ADDENDUM NO. 04 (MEPT)

Date of Issuance: April, 23, 2026

Project: **Replacement Elementary on Mustang Rd.**
Alvin Independent School District

Texas Arcadis Inc.
Project No.: 202502 - 30268973

1 UNDERSLAB PLUMBING PLAN - AREA B0
1/8" = 1'-0"

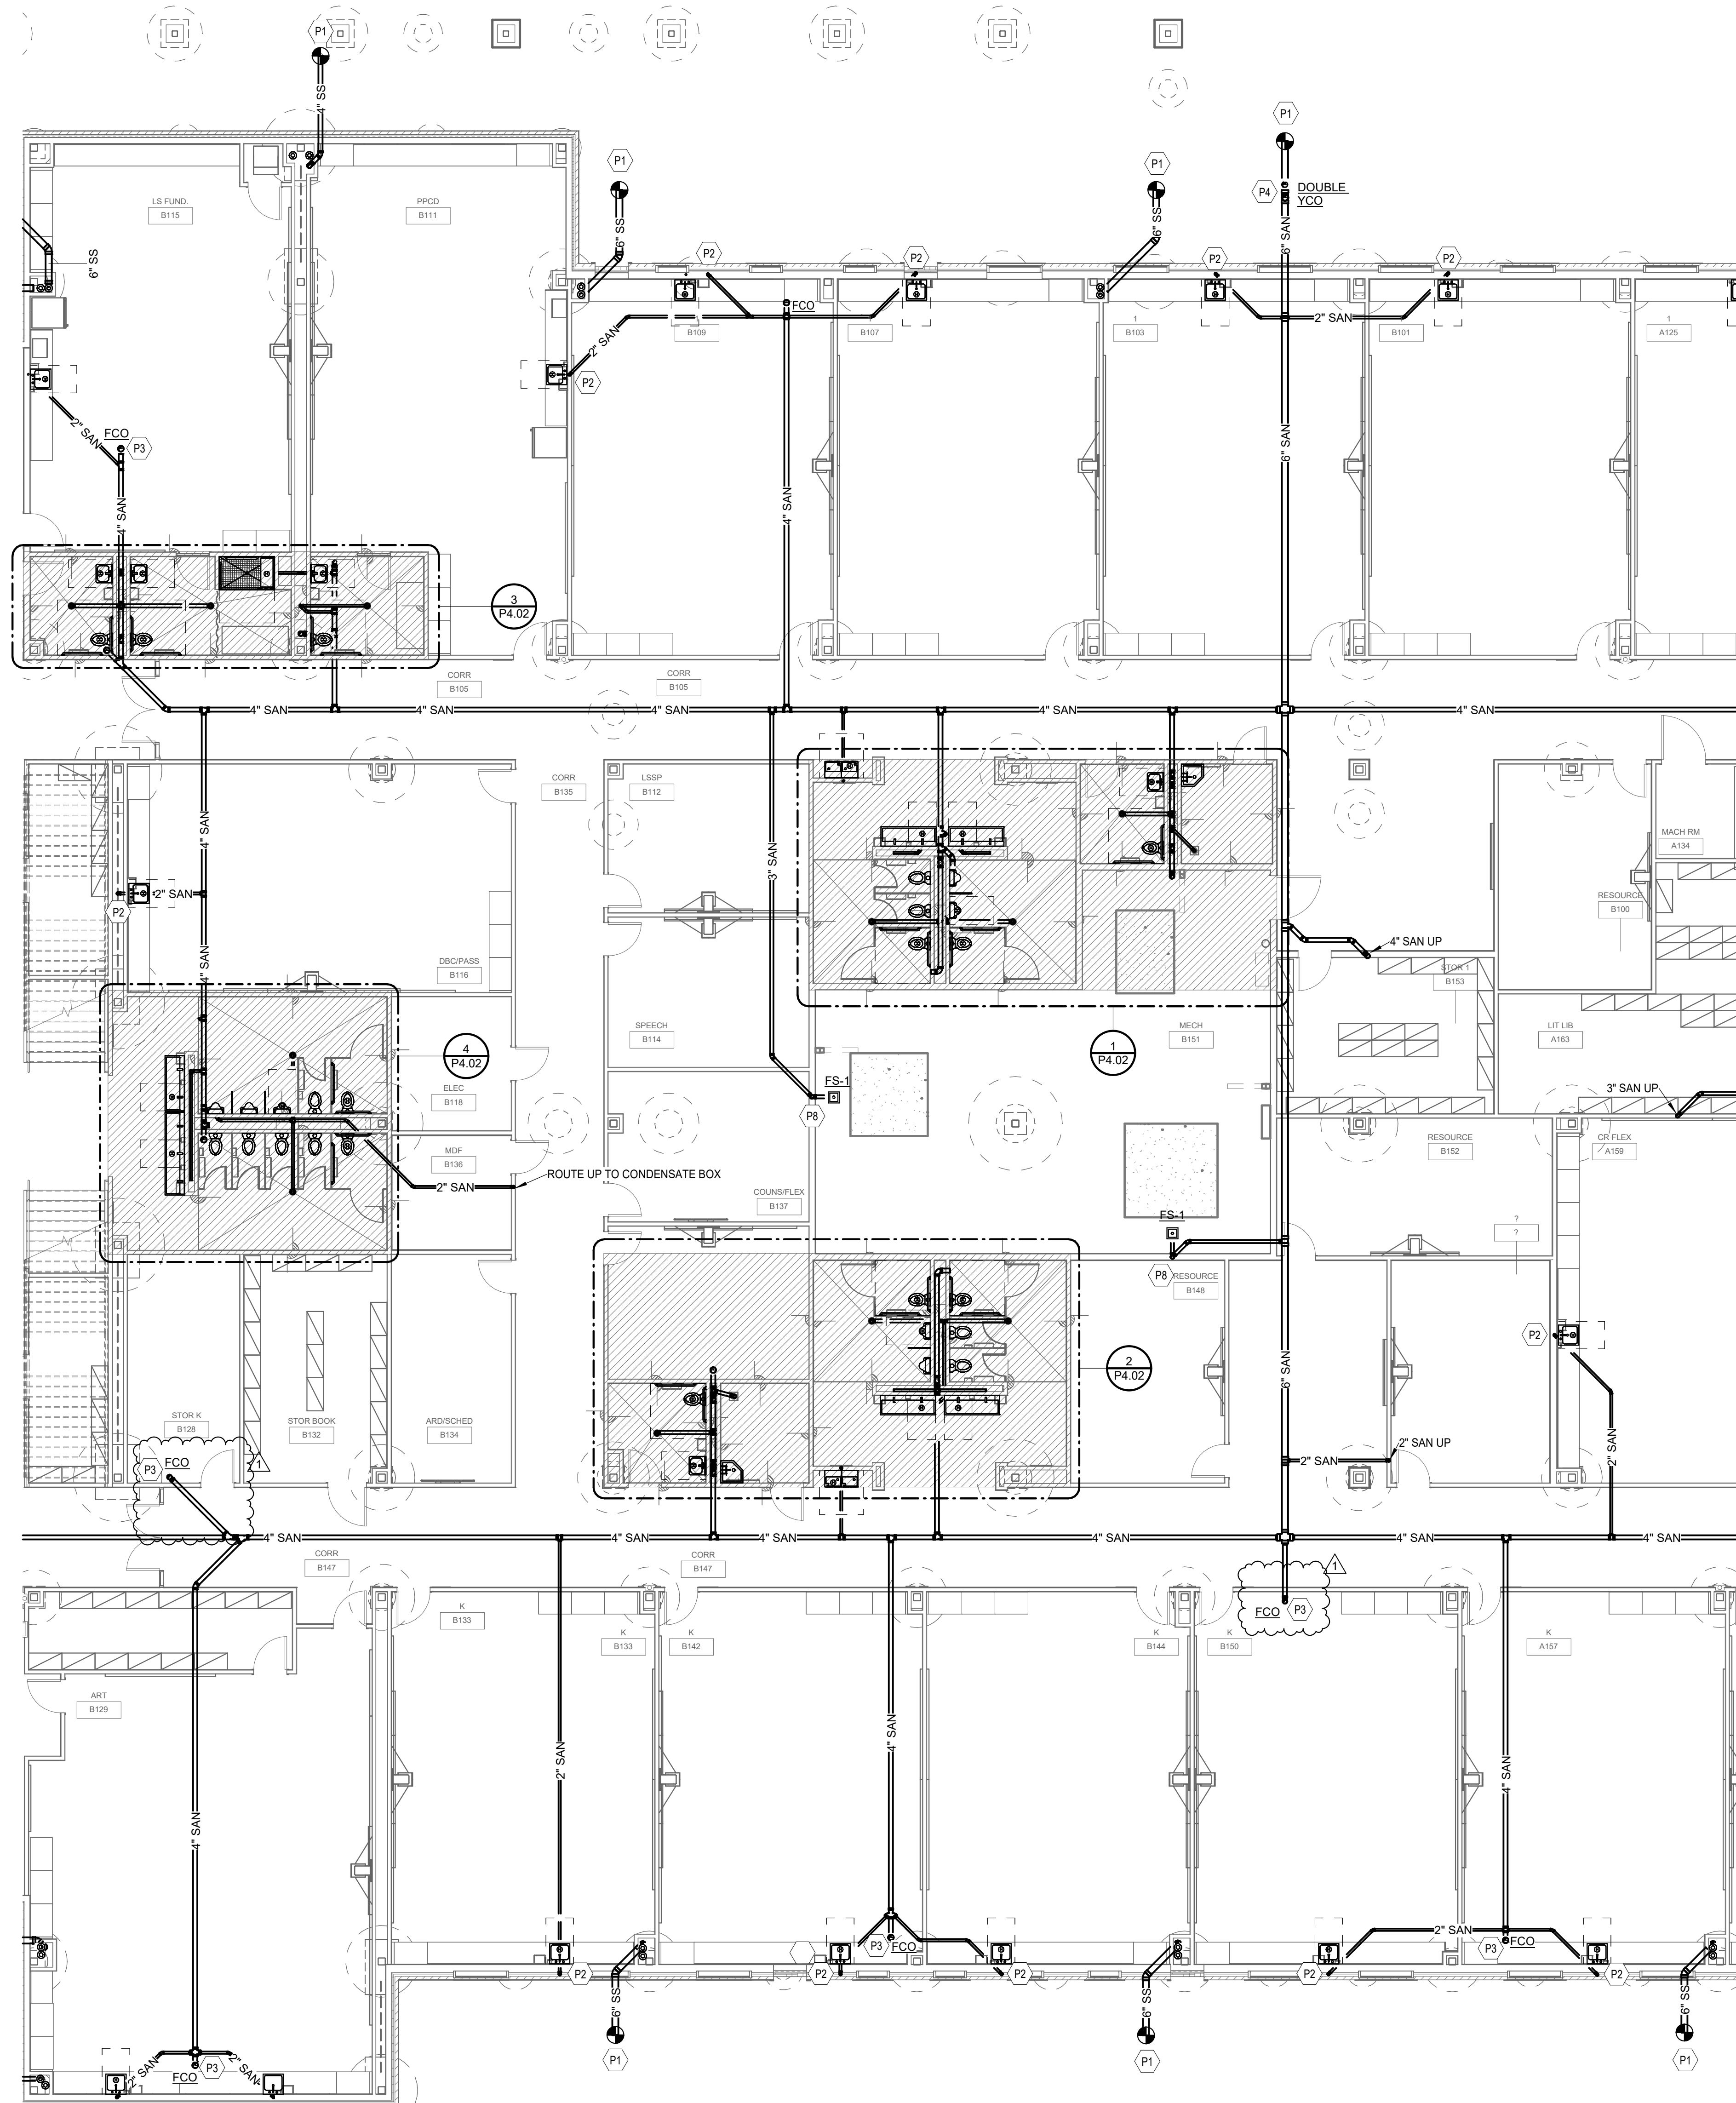
24. Sheet P2.01 – UNDERSLAB PLUMBING - AREA A0
 - a. Revised sanitary routing.
25. Sheet P2.02 – UNDERSLAB PLUMBING - AREA B0
 - b. Revised sanitary routing.

1 UNDERSLAB PLUMBING PLAN - AREA D0
1/8" = 1'-0"

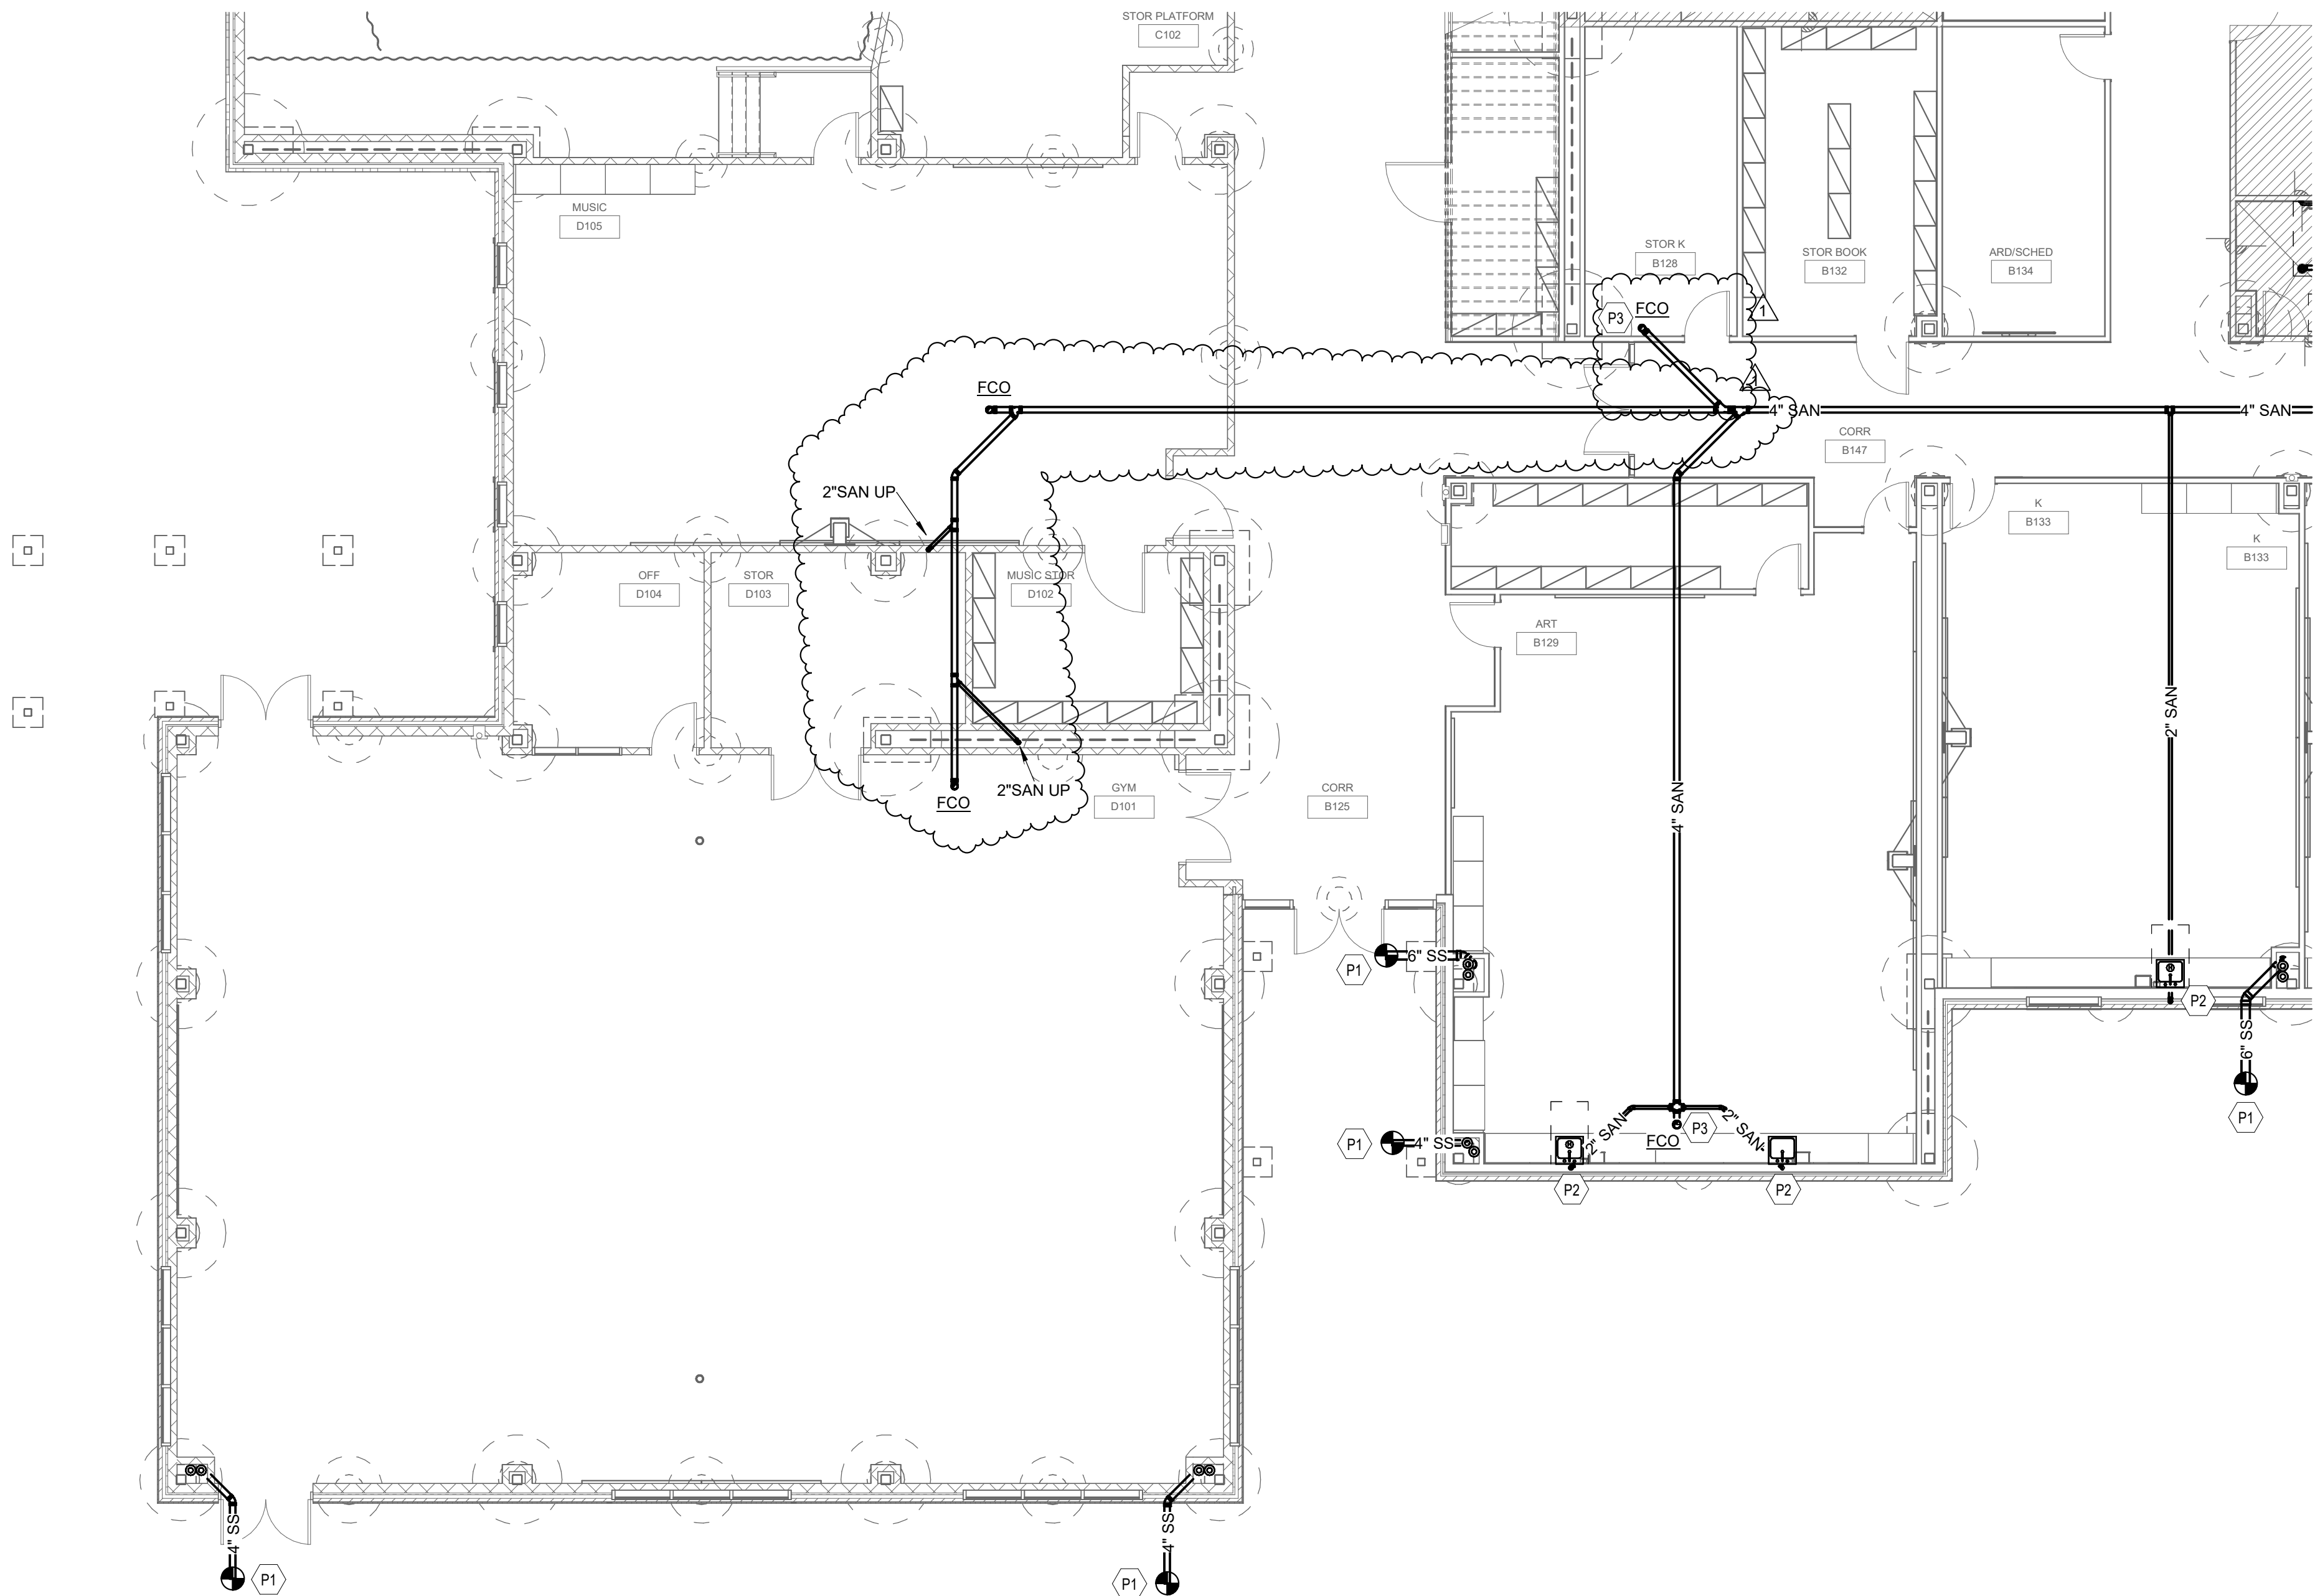
8. Page P2.04 near rooms D103, D102 missing underground sanitary plumbing for FS-1's above on 2nd floor . Please submit drawings.
 - a. **CMTA Response:** Under slab drawings will be updated to pick this up.

26. Sheet P2.04 – UNDERSLAB PLUMBING - AREA D0
 - c. Revised sanitary routing.
27. Sheet P2.11 – LEVEL 1 PLUMBING - AREA A1
 - d. Revised cold and hot water routing.

P2.12
LEVEL 1 PLUMBING -
AREA B1

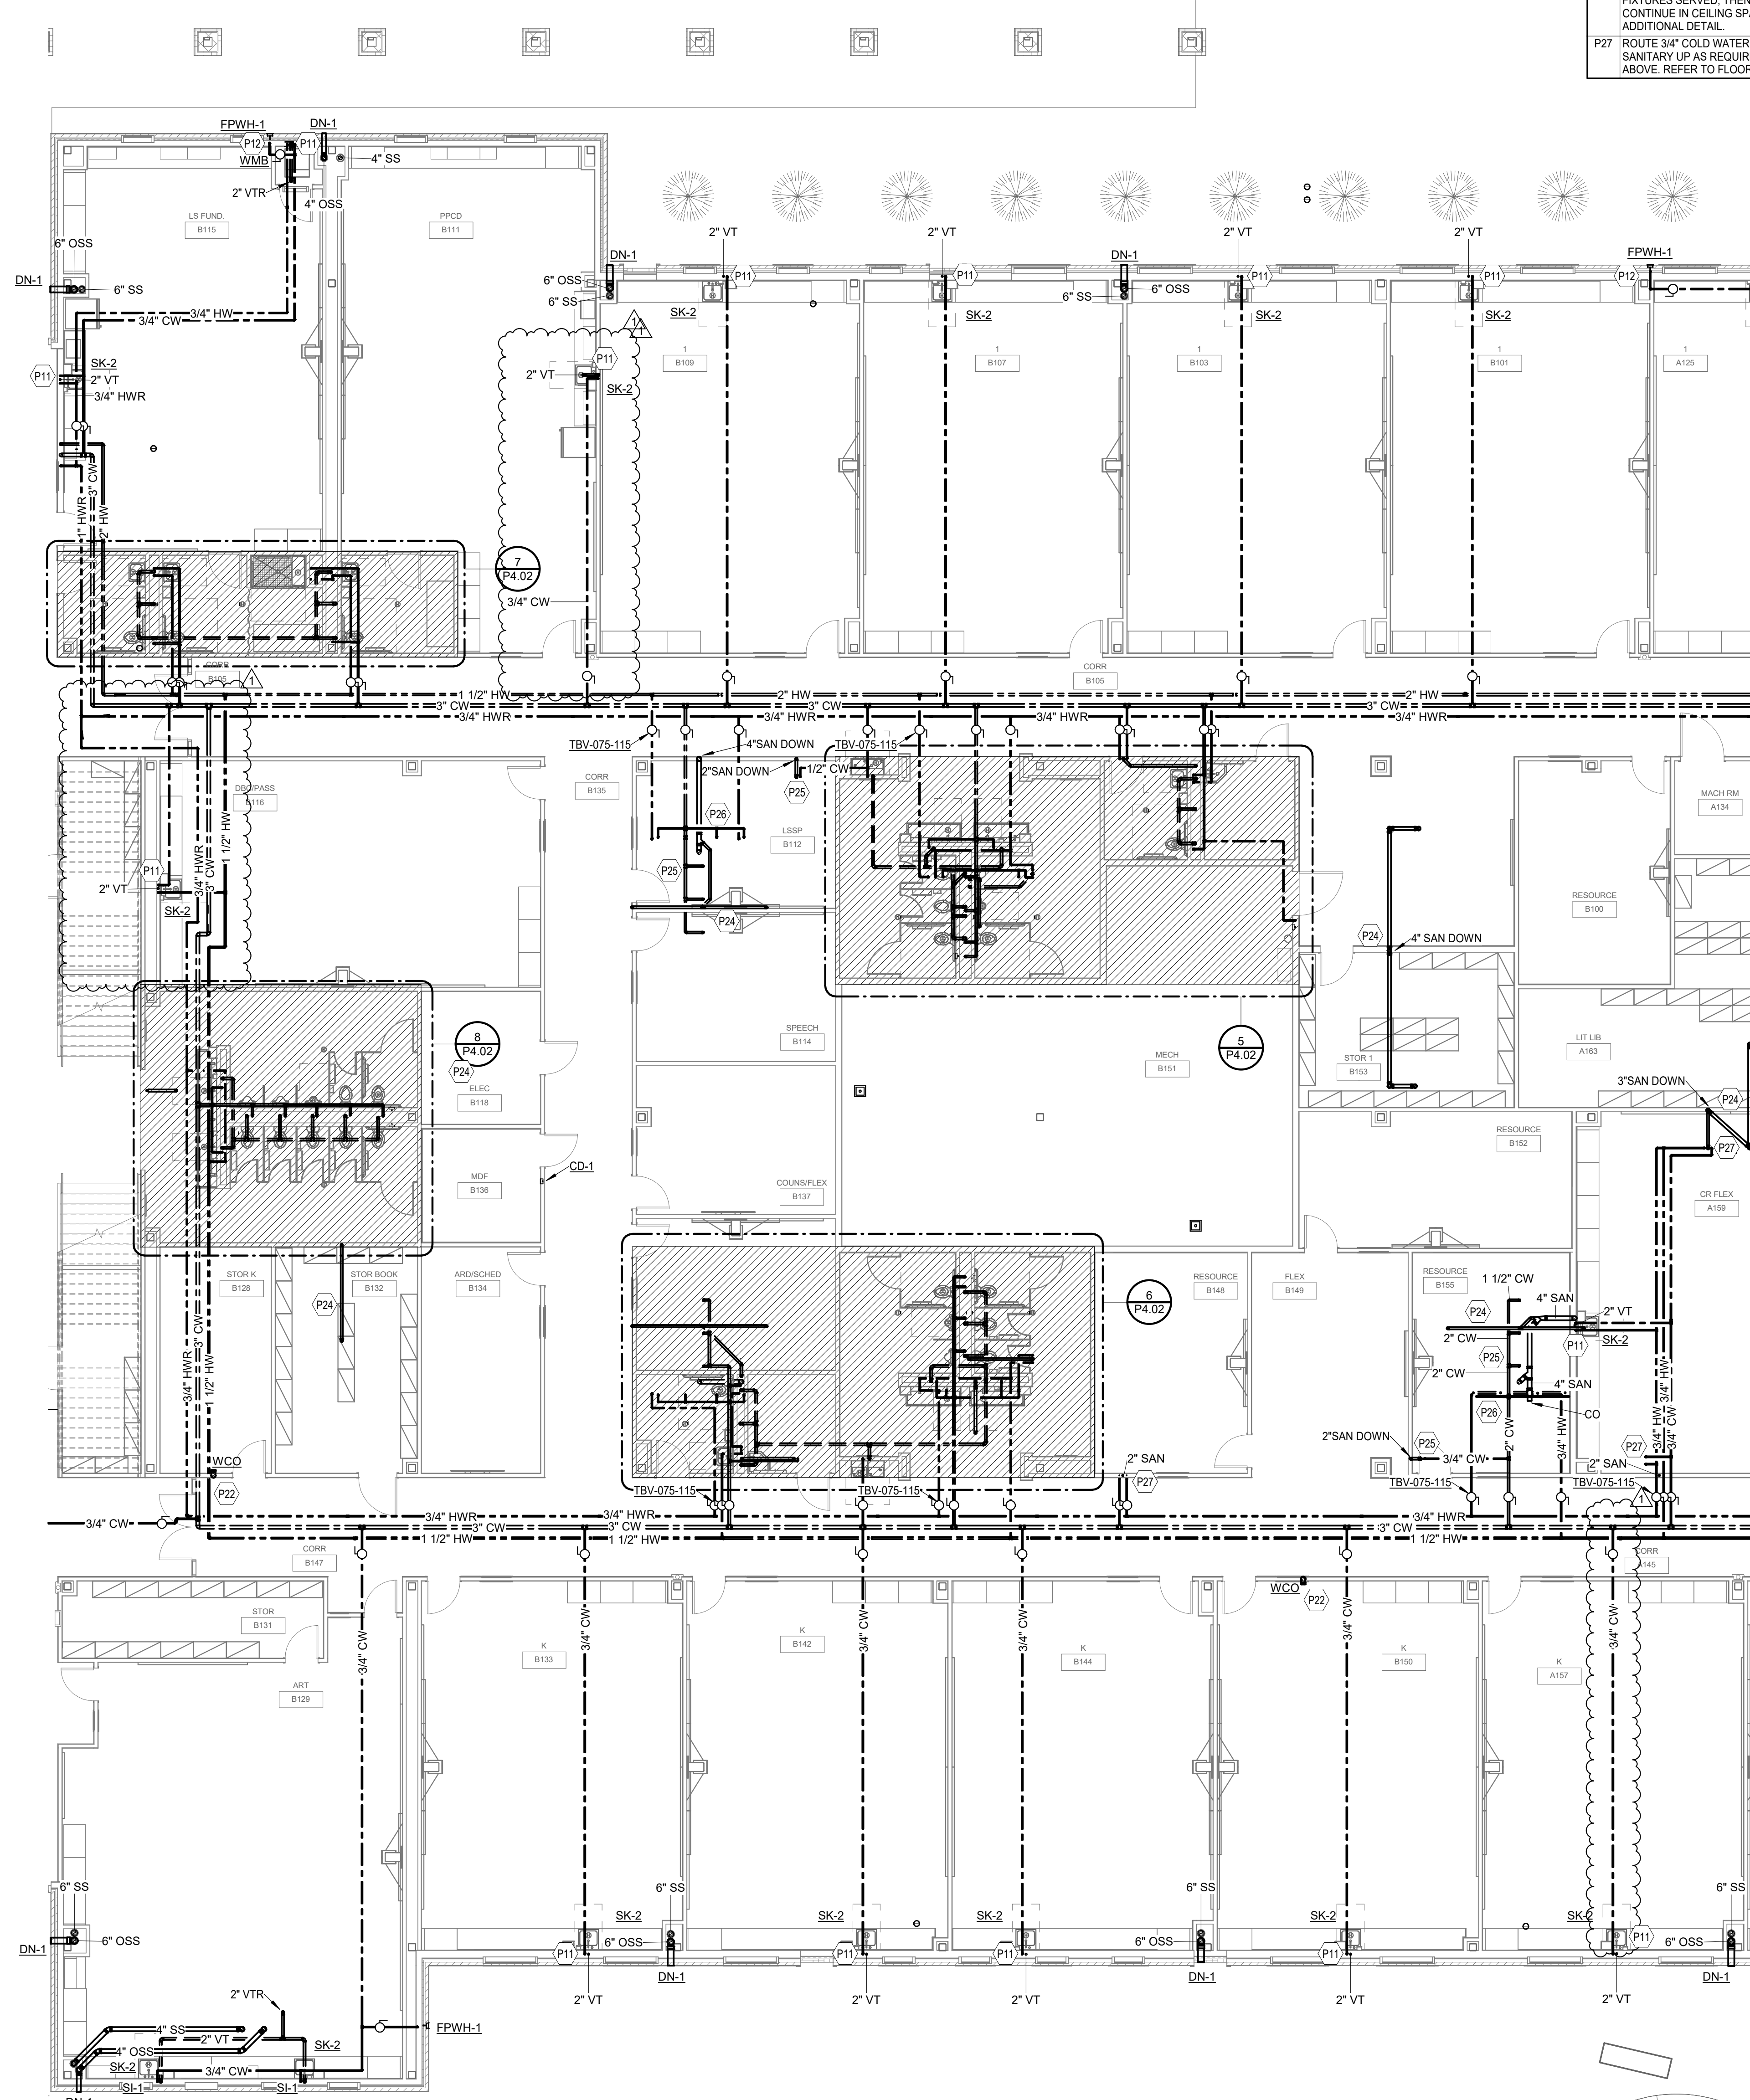
28. Sheet P2.12 – LEVEL 1 PLUMBING - AREA B1
 - a. Revised cold and hot water routing.
29. Sheet P2.13 – LEVEL 1 PLUMBING - AREA B1
 - b. Revised cold and hot water routing.
